**Town of Kittery
Planning Board Meeting
August 10, 2023**

ITEM 4 – 17 & 25 Route 236 –Site Plan– Sketch Plan Review

Proposal: Develop a 61-bed rooming house and associated parking shared with an existing 7-unit apartment.

Location: 17 & 25 US Route 236 Map 21 Lot 20 & Map 20, Lot 12

PROPOSED SITE PLAN

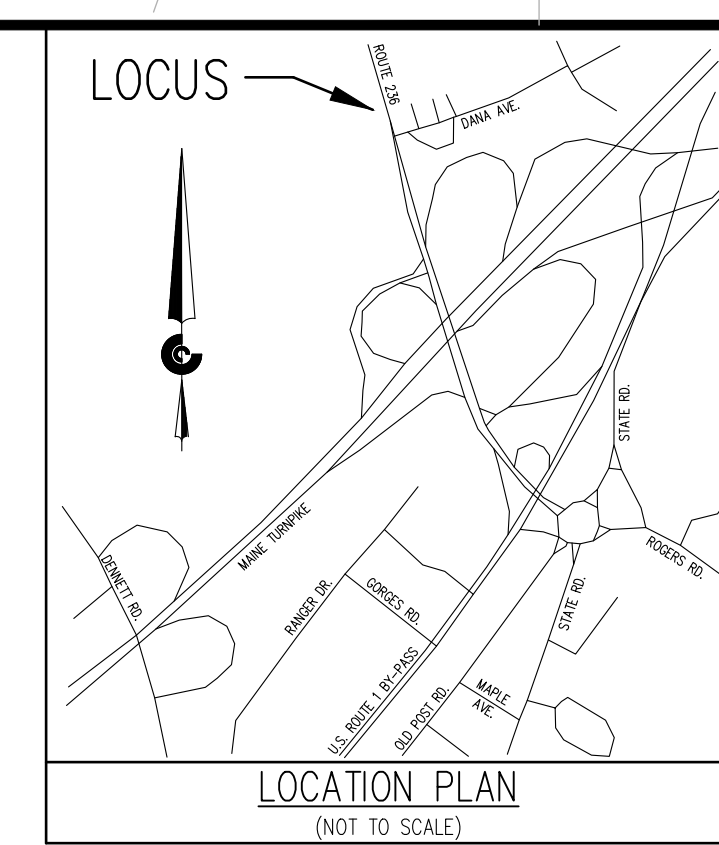
- 64 1. As required in the C-2 zone, proposed utilities are underground in the site plan.
 65 2. The plan indicates the proposed area for a force sewer main and pump station, as well as stormwater
 66 BMP areas. Staff suggest the applicant confirm with Wastewater staff that treatment systems will
 67 have the capacity for the multi-unit project.

- 74 1. The existing driveway is non-conforming due to its failure to meet setbacks to the abutting wetland.
 75 The development cannot increase its nonconformity to the wetland setback.

- 76 2. The applicant stated the driveway is roughly 420 linear feet. Per §16.3, a driveway must be 500 feet or
77 shorter, or it is considered a right of way and must meet dimensional standards.
78 3. Public works staff noted an existing culvert in the driveway is undersized and requires restoration and
79 potential upsizing. Because the driveway is privately owned, it is the responsibility of the owner to
80 maintain it.

- 83 1. The plan requests relief on minimum parking requirements. The standard calls for 2 spaces per
84 apartment unit, and 1 space per rental unit in the rooming house. With 7 apartments and 35 units,
85 this would require 47 spaces, but the plan proposes a total of 35. The applicant claims parking
86 requirements will be minimized as the rooming house will cater solely to seasonal workers, and
87 the owner will provide carpool services to employees. They are seeking to provide 1 parking
88 space for every 3 beds, rather than for every single rental unit in the rooming house.
89 2. The proposed plan currently meets the requirement of ADA parking spaces.
90
